**MONTGOMERY WATSON**

Response to: U.S. EPA's August 5, 1996 Approval of the First Draft,  
Technical Memorandum, Dewatering/Barrier Wall Alignment  
Investigation Report with Modifications  
American Chemical Service NPL Site,  
Griffith, Indiana

Required Modifications for First Draft, Technical Memorandum,  
Dewatering/Barrier Wall Alignment Investigation Report, American  
Chemical Services NPL Site, Griffith, Lake County, Indiana.

FIGURE 2

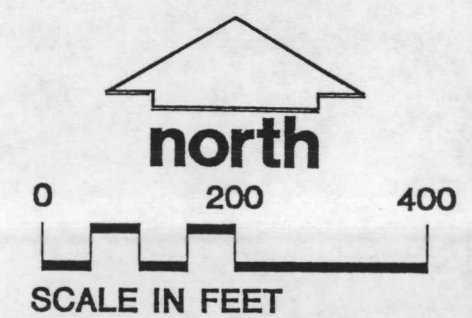
Placement of the alignment just east of SB205 as suggested here, and indicated on figure 2, will exclude soils classified as waste (based on paragraph 3). If the alignment is to remain as proposed, removal action (with conformational sampling) will be necessary to ensure that soils exceeding waste criteria are removed.

**Section 4.4 has been added on Page 11 to discuss the new revised and U.S. EPA approved Barrier Wall Alignment. It includes the sentences, "It is possible that some areas of waste will remain outside the barrier wall. To the extent that such areas do exist, they will be appropriately addressed by the overall site remedy."**
